FTM-150R/E Series – Changes in Functions

Date: April 22, 2025

Switchable between Frequency Display and name (TAG) Display on the PMG screen and Scope screen

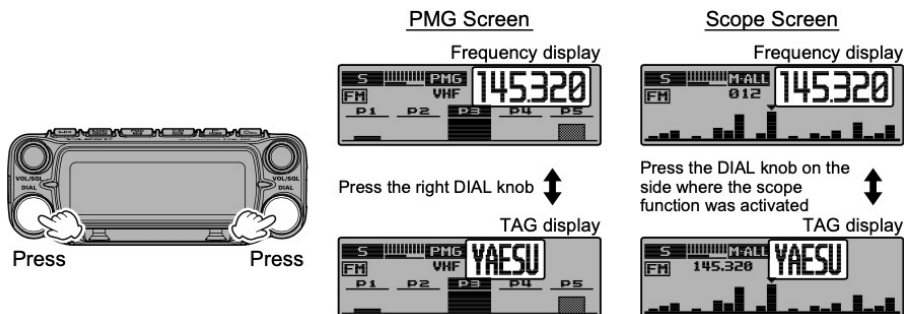
For memory channels with names (TAG), the frequency display and TAG display are switchable. On the PMG screen, you can switch between them by briefly pressing the right DIAL knob. On the scope screen, by briefly pressing the DIAL knob on the side where the scope function is activated, TAG/ frequency displays are switchable.
